Open Record Exhibit OR-1A

Public Testimony

I am writing to express my **strong opposition** to the proposed Blackberry Grove Battery Energy Storage System (BESS) by Jupiter Power at 21393 NW West Union Road in Hillsboro, Oregon.

Re: Jupiter Power “Blackberry Grove” Battery Energy Storage System (BESS)
Washington County Case No. L2500161

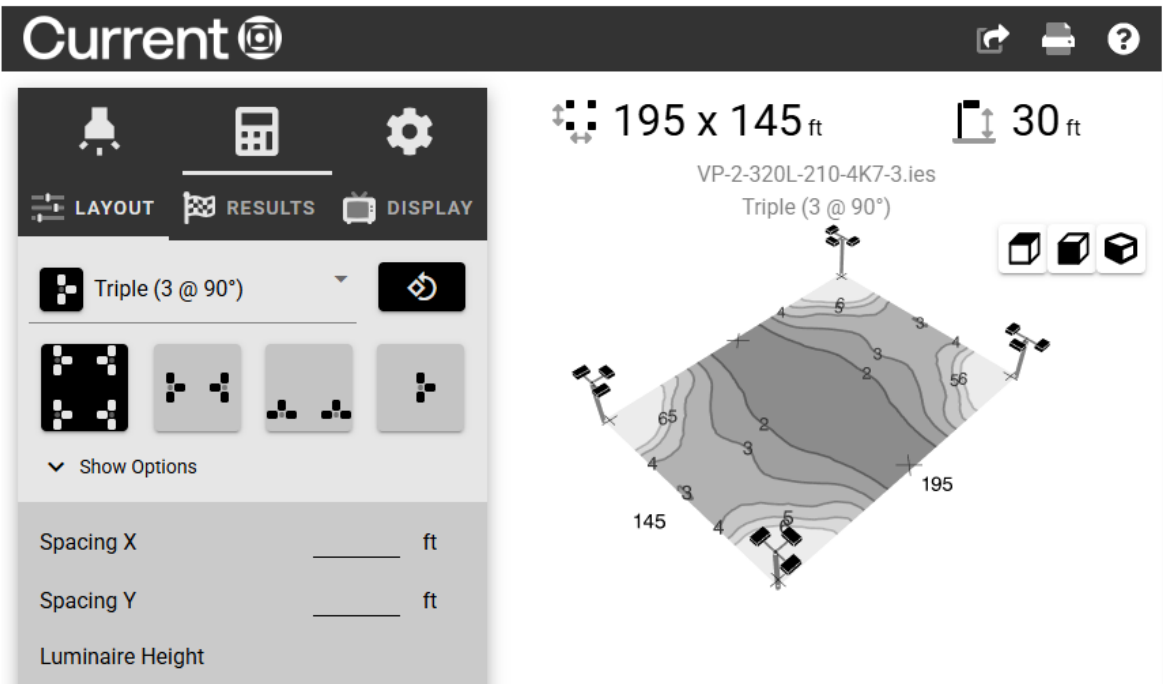
Lights being mounted on poles at 30 ft near adjacent properties makes it very difficult to believe that there would be “minimal impact to adjacent properties and habitat” to the surrounding neighborhood. Currently there are no street lights in the Bendemeer neighborhood. Adding 48 – 30,000 lumen and 8 – 43,000 lumen light fixtures to a dark area will definitely have an impact.

According to DarkSky.org (<https://darksky.org/>), Section 2.0 Lighting Criteria: The light source CCT shall not exceed nominal 3000 K. Therefore, 56 of the 58 proposed light fixtures do not meet the requirements to be dark sky compliant.

Based on the manufacturer’s website for the 48 fixtures noted in the preliminary site plan (<https://www.currentlighting.com/outdoor-lighting/viper-area-size-2/9606404>) with the lumens, watts, number and arrangement, the following light map was provided from the manufacturer:

Nothing in the proposed site plan will help deflect the amount of light this facility will generate and affect the neighboring properties to excess light exposure in a current dark neighborhood. Currently there are four poles on the backwall of the proposed plan that are backed up directly to residential properties. Four other poles are placed on the south side of the back pods. These lights will have an illumination impact when placed 30' up a pole where the wall will only be 12' high. The current trees that are on site will be impacted due to construction and more than likely will die within 5 years leaving every adjacent property susceptible to direct excessive light exposure.

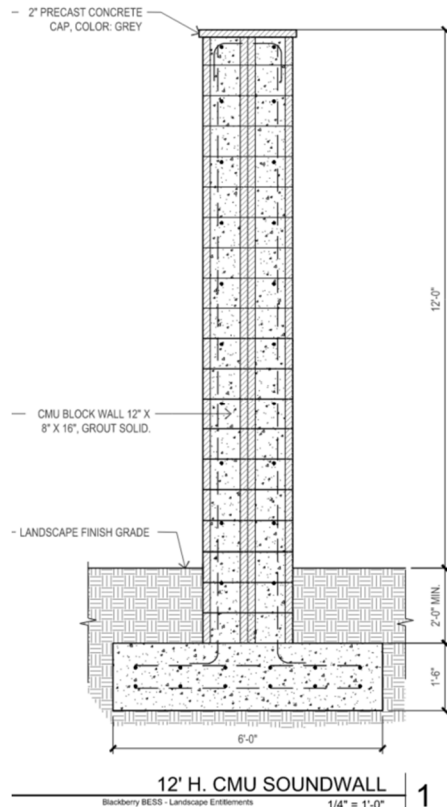
The sound levels were modeled with an industry-standard modeling program, CadnaA, which follows the ISO 9613-2 standard calculation methods. However, a person with no specific training and certification in environmental noise or the specific software program can make significant errors in entering and interpreting data used as the basis for the calculations. For instance, if the actual ground type is not accurately input, the sound reduction over distance can be erroneous. The person who did the modeling should be trained and qualified to run and interpret the software results -- this information should be confirmed by Dudek for the person who did the modeling.

All operations and activities on the site are applicable to the sound limits, but the report says the sound calculations were limited to three equipment types only: BESS, Transformer, and PCS. Furthermore, the actual transformer sound levels are only estimated, not measured or provided by the manufacturer. The electrical switches, transfer, alarms, and any other on-site equipment were not included in the calculation. This may lead to erroneous results for the L1, L10, L50, impulse, octave, and 1/3 octave limits. The sound levels for these other devices and equipment should be listed to prove they are not an issue.

The assumptions used for the equipment operating conditions may not be worst-case. Are 95% fan speed and 7,000 RPM the worst case or the typical case, and how often would it be above these levels? Sound levels can often rise significantly, going from 95% to 100% fan speeds, for instance. Full manufacturer sound data should be provided for review.

Pure tones are noted for the BESS and PCS systems, which triggers the DEQ requirement for 1/3 octave analysis and limits. The 1/3 octave criteria require 1/3 octave data which is not provided in the report, so the graph shown in Figure 2 is erroneous and misleading. The graph uses the octave band data which is not high enough resolution to determine whether or not a tone exists, per the requirement. In any case the report does indicate tones are present. Also, typical transformers “hum” at 120 Hz and other harmonic frequencies, but this is not included in the tonal analysis.

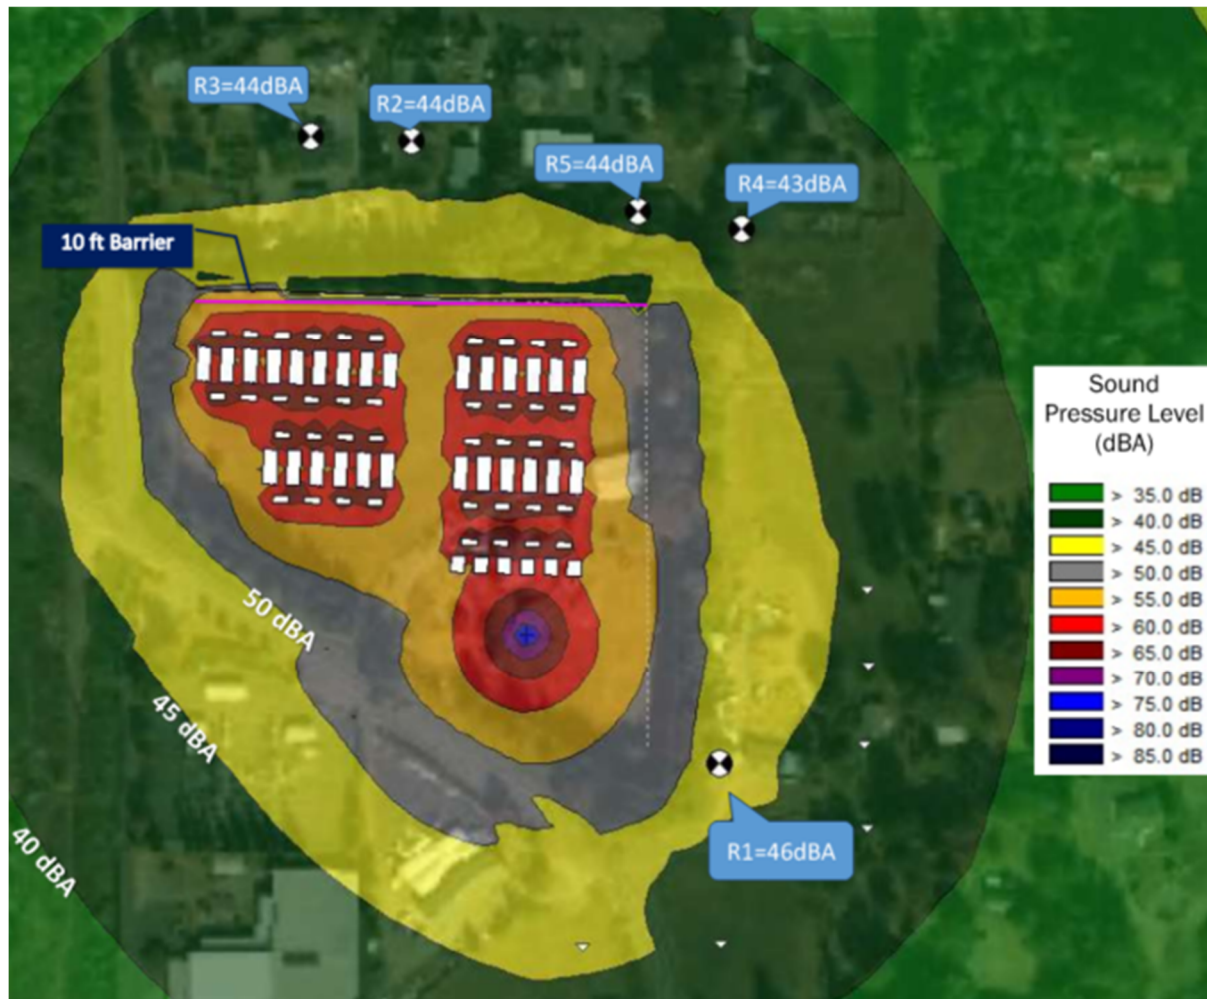
Modeled/Calculated Results: Without doing a full calculation, a rough rational number check is as follows:

- Source level is 74.5 dBA (sound power) for one BESS unit.
- Source level is 86 dBA (sound power) for one BESS unit.
- For 120 BESS units, the sound level is roughly 95 dBA (sound power)
- For 40 PCS units, the sound level is roughly 100 dBA (sound power)
- Specific distances are not tabulated and no details are provided for the calculation inputs, beyond displaying the modeling results.
- The approximate sound level at the closest property lines with no barrier would likely be much higher than the 43-46 dBA L50 shown on the table.

The graphical sound prediction data seems low. The sound power level of the transformer is 100 dBA, but the graphics below show it at 75 dBA (blue) sound pressure level right at the source and the scale doesn't even go to 100 dBA. Sound levels around the BESS and PCS only show 65 dBA, which is well below the 74-86 dBA source levels.

Propagation within the property would be over hard ground, such as gravel or pavement, but it's not clear if this is in the model. The reflection of hard ground will increase sound levels vs. soft earth. Also reflections off of the large equipment (BESS, etc.) will amplify sound levels in some directions.

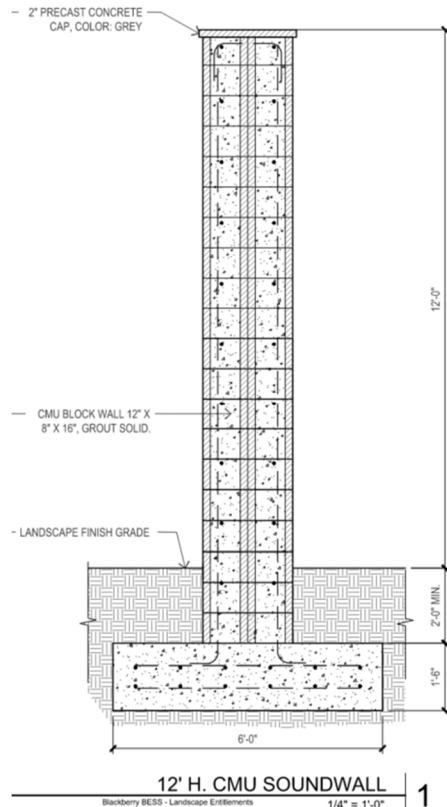
The sound levels were modeled with an industry-standard modeling program, CadnaA, which follows the ISO 9613-2 standard calculation methods. However, a person with no specific training and certification in environmental noise or the specific software program can make significant errors in entering and interpreting data used as the basis for the calculations. For instance, if the actual ground type is not accurately input, the sound reduction over distance can be erroneous. The person who did the modeling should be trained and qualified to run and interpret the software results -- this information should be confirmed by Dudek for the person who did the modeling.

All operations and activities on the site are applicable to the sound limits, but the report says the sound calculations were limited to three equipment types only: BESS, Transformer, and PCS. Furthermore, the actual transformer sound levels are only estimated, not measured or provided by the manufacturer. The electrical switches, transfer, alarms, and any other on-site equipment were not included in the calculation. This may lead to erroneous results for the L1, L10, L50, impulse, octave, and 1/3 octave limits. The sound levels for these other devices and equipment should be listed to prove they are not an issue.

The assumptions used for the equipment operating conditions may not be worst-case. Are 95% fan speed and 7,000 RPM the worst case or the typical case, and how often would it be above these levels? Sound levels can often rise significantly, going from 95% to 100% fan speeds, for instance. Full manufacturer sound data should be provided for review.

Pure tones are noted for the BESS and PCS systems, which triggers the DEQ requirement for 1/3 octave analysis and limits. The 1/3 octave criteria require 1/3 octave data which is not provided in the report, so the graph shown in Figure 2 is erroneous and misleading. The graph uses the octave band data which is not high enough resolution to determine whether or not a tone exists, per the requirement. In any case the report does indicate tones are present. Also, typical transformers “hum” at 120 Hz and other harmonic frequencies, but this is not included in the tonal analysis.

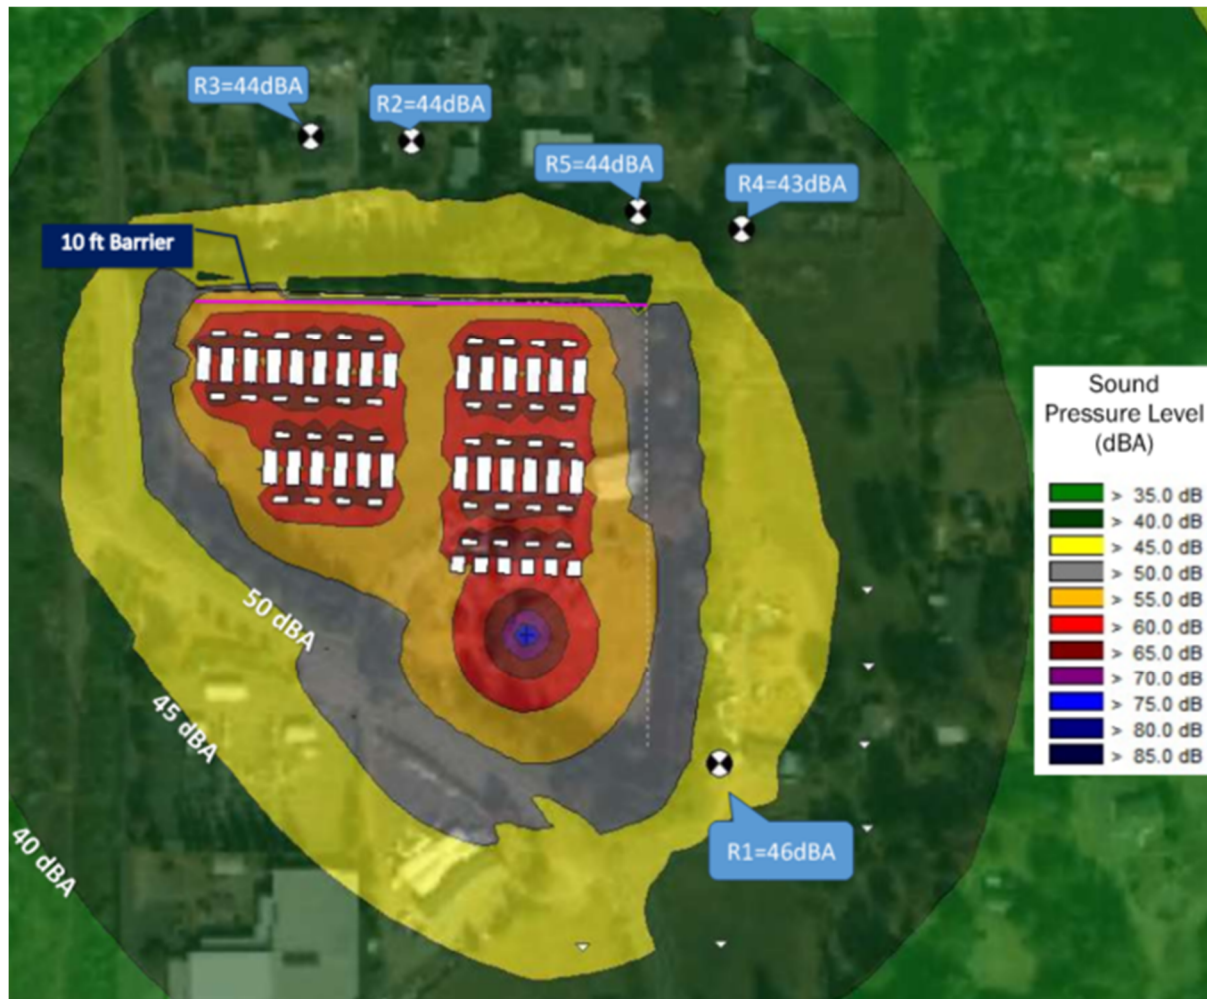
Modeled/Calculated Results: Without doing a full calculation, a rough rational number check is as follows:

- Source level is 74.5 dBA (sound power) for one BESS unit.
- Source level is 86 dBA (sound power) for one BESS unit.
- For 120 BESS units, the sound level is roughly 95 dBA (sound power)
- For 40 PCS units, the sound level is roughly 100 dBA (sound power)
- Specific distances are not tabulated and no details are provided for the calculation inputs, beyond displaying the modeling results.
- The approximate sound level at the closest property lines with no barrier would likely be much higher than the 43-46 dBA L50 shown on the table.

The graphical sound prediction data seems low. The sound power level of the transformer is 100 dBA, but the graphics below show it at 75 dBA (blue) sound pressure level right at the source and the scale doesn't even go to 100 dBA. Sound levels around the BESS and PCS only show 65 dBA, which is well below the 74-86 dBA source levels.

Propagation within the property would be over hard ground, such as gravel or pavement, but it's not clear if this is in the model. The reflection of hard ground will increase sound levels vs. soft earth. Also reflections off of the large equipment (BESS, etc.) will amplify sound levels in some directions.
